UNITED STATES PATENT AND TRADEMARK OFFICE

10/574,049

Office Action Summary	Application No. 10/574,049	Applicant(s) JAGGAN-VINCE, CINTRA	
	Examiner OPHELIA HAWTHORNE	Art Unit 3772

DETAILED ACTION

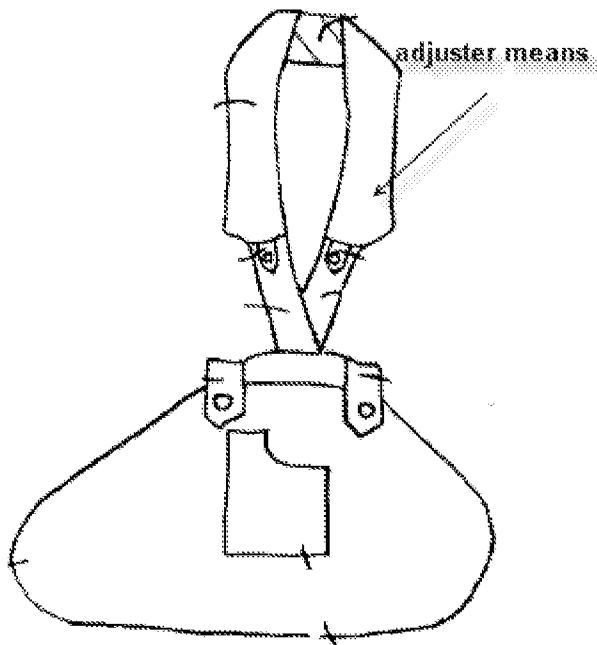
Regarding claim 1, O’Brien discloses a sling assembly (**Fig. 2**) for supporting an arm of a user, which sling assembly comprises a support portion (**4**) for being worn by the user, a sling portion (**2**) for supporting the arm of the user and fastener means for fastening the sling portion to the support portion, characterized in that the fastener means is a releasable fastener means for enabling the sling portion to be fastened and unfastened with respect to the support portion for exercise purposes with the sling portion still being worn, the sling portion does not extend around the elbow of the arm (**as shown in Fig. 1**) and thereby restrict elbow movement whereby elbow problems are prevented from developing when the sling assembly is worn for extended periods of

time, and the fastener means is a single fastener means for one-handed one-time operation by the user. Note: O'Brien discloses alternate means such as hook and loop for attaching the sling portion to the support portion and therefore, meet the claimed limitation as a single fastening means for enabling the sling portion to be fastened and unfastened for a one-time one-handed operation by the user.

Regarding claim 2, O'Brien discloses an adjuster means (**see image below**) for adjusting the sling portion with respect to the support portion and thereby to enable the arm of the user to be supported in an optimum comfortable position. Note: it should be noted that examiner considers the strap to be the adjuster means since the strap can be lengthen and/or shorten according to the user's comfort level.

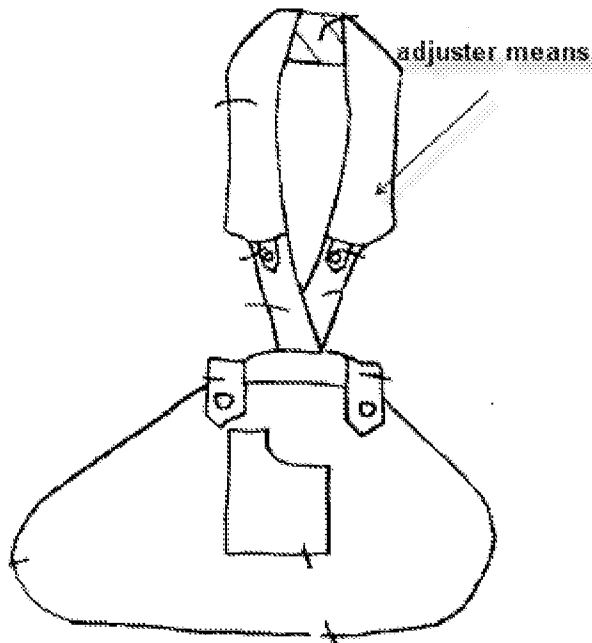
Regarding claim 12, O'Brien discloses the sling assembly does not engage an upper part of the arm **(as shown in Fig. 1)** such as to restrict movement of the shoulder of the user from which the arm extends thereby to allow shoulder movement and prevent shoulder problems developing when the sling assembly is worn for extended period of time.

Regarding claim 13, O'Brien discloses the adjuster means is an adjuster means which extends obliquely **(see image below)** with respect to the longitudinal axis of the user whereby the shoulder of the user from which the arm extends is given support in a direction towards the user's body.

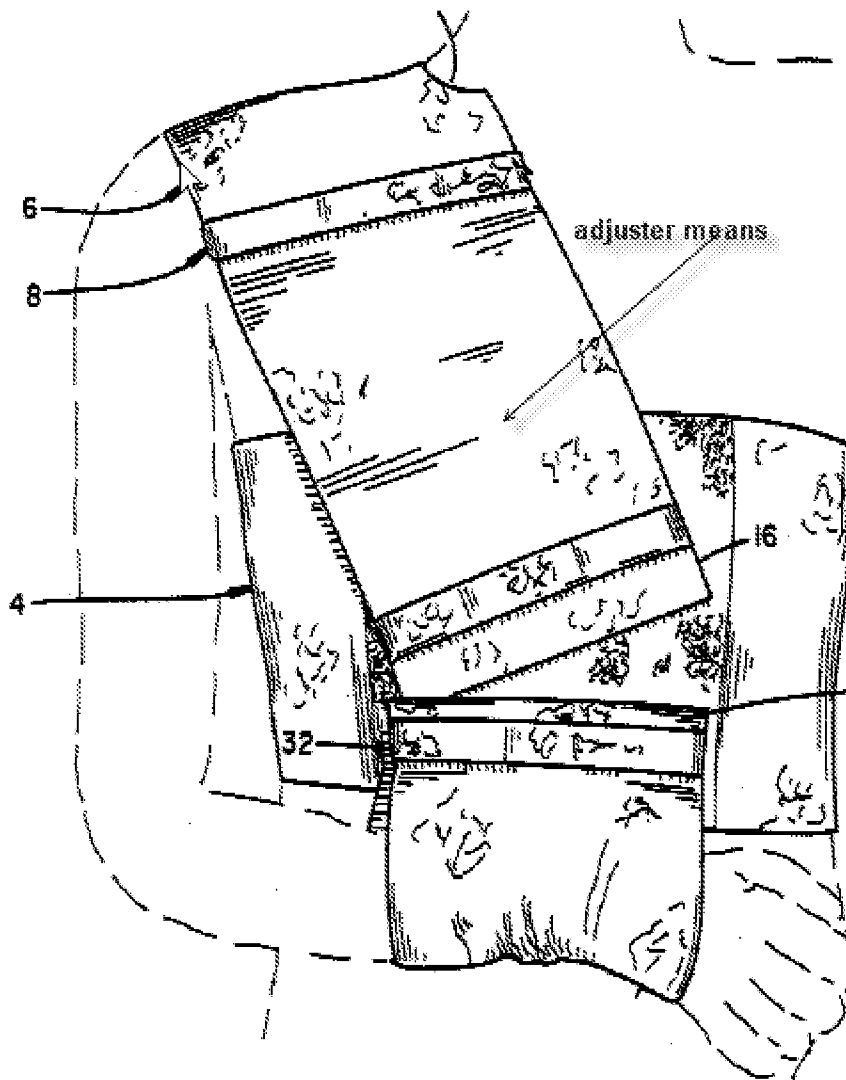
Regarding claim 1, Johnson discloses a sling assembly (**Fig. 1**) for supporting an arm of a user, which sling assembly comprises a support portion (**10**) for being worn by the user, a sling portion (**8**) for supporting the arm of the user and fastener means (**32**) for fastening the sling portion to the support portion, characterized in that the fastener means is a releasable fastener (**[Col. 4], line 21**) means for enabling the sling portion to be fastened and unfastened with respect to the support portion for exercise purposes with the sling portion still being worn, the sling portion does not extend around the elbow (**as shown in Fig. 1**) of the arm and thereby restrict elbow movement whereby elbow problems are prevented from developing when the sling assembly is

worn for extended periods of time, and the fastener means is a single fastener (32) means for one-handed one-time operation by the user.

Regarding claim 2, Johnson discloses an adjuster means for adjusting the sling portion with respect to the support portion and thereby to enable the arm of the user to be supported in an optimum comfortable position. Note: it should be noted that examiner considers the strap to be the adjuster means since the strap can be lengthen and/or shorten according to the user's comfort level.

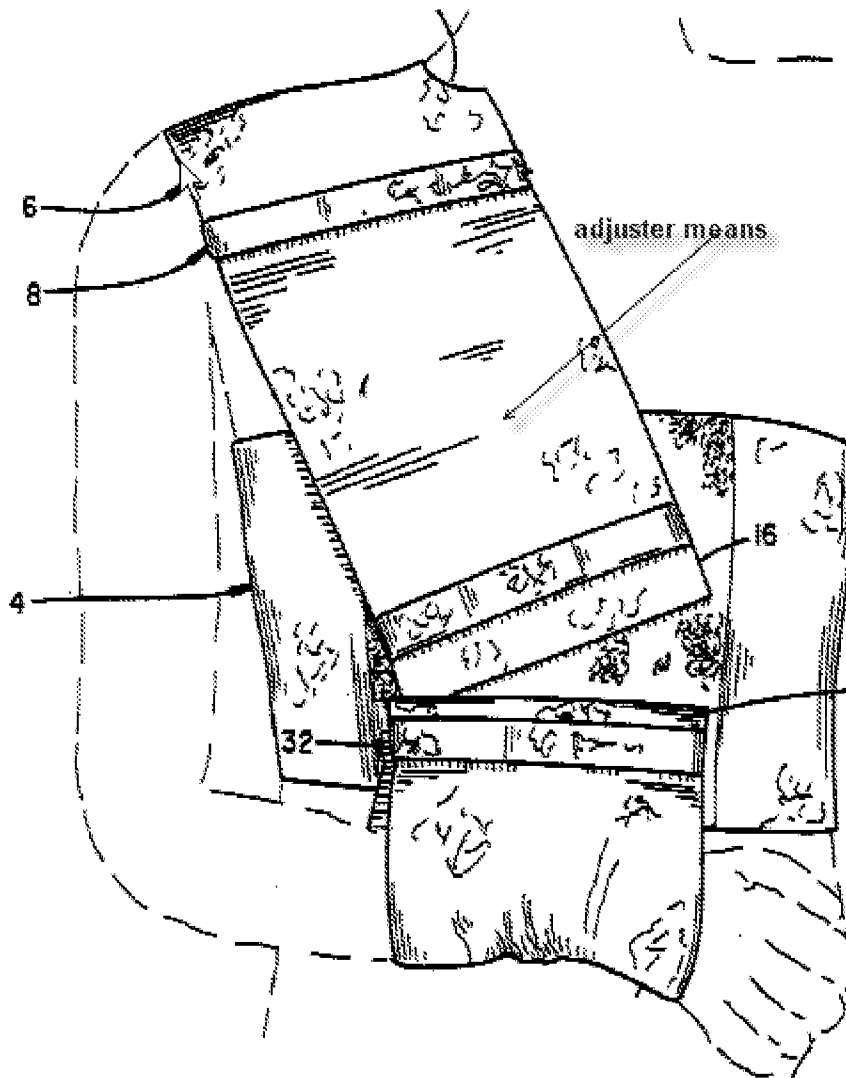
Regarding claim 4, Johnson discloses the fastener means **(32)** and the adjuster means **(see image above)** are separately formed from each other.

Regarding claim 13, Johnson discloses the adjuster means is an adjuster means which extends obliquely **(see image below)** with respect to the longitudinal axis of the user whereby the shoulder of the user from which the arm extends is given support in a direction towards the user's body.
